“Narrabri not the best solution for eastern Australia’s gas supply”

Context

The proposed Narrabri Lateral Pipeline (NLP) project will carve a 20-to-30 metre corridor for over 50 kilometres, with its path heading through pristine sections of the Pilliga forest, private properties, and public land. Santos want this project approved so they can connect 850+ new gas wells. These wells will be drilled through the unique and irreplaceable Great Artesian Basin which is essential for life in the area.

Santos' EIS documents for the Narrabri Lateral Pipeline were first made available for comment on 20th November 2025, with submissions closing on 18th December 2025.

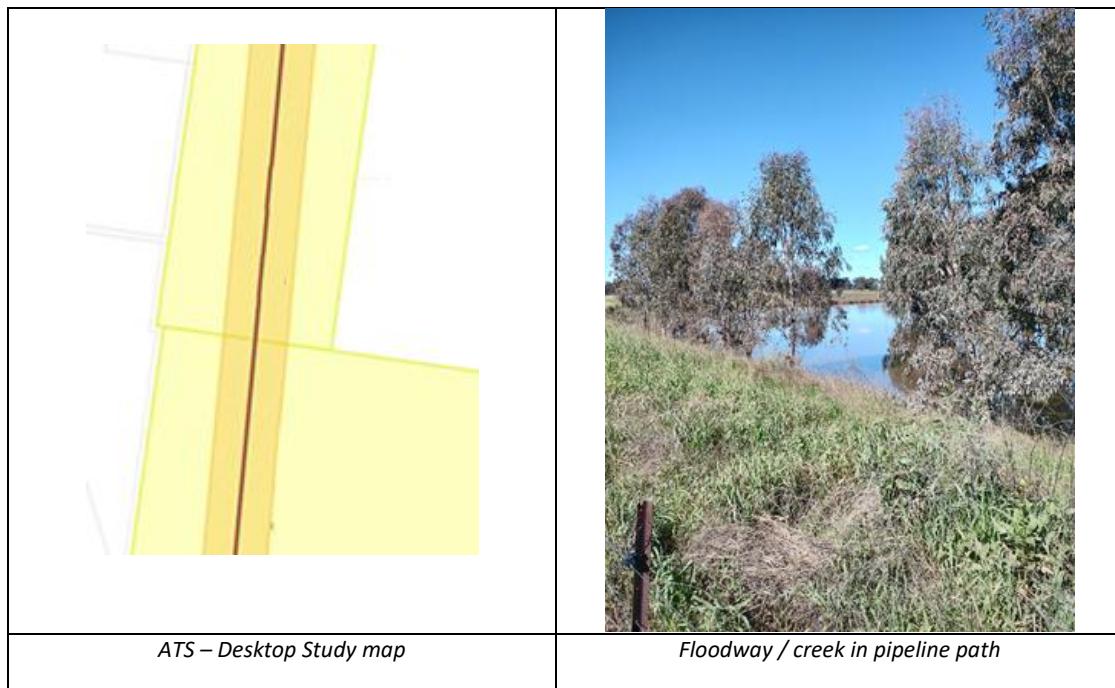
For example, the “desktop study” map on the left below shows a page from the Hunter Gas Pipeline’s Authority-To-Survey document.

The desktop study map purports to show that there are zero waterways on the property.

The image on the right shows an August 2025 “on the ground” photograph of a 2m deep floodway lagoon / creek that the pipeline will have to cross, a natural floodway creek that a “ground truth” survey would have revealed.

Such gross errors strongly imply that any EIS that relies on desktop studies is likely to be deeply flawed.

The whole of the length of the NLP path needs to be fully surveyed on the ground to document all waterways and to identify all “at risk” flora and fauna.
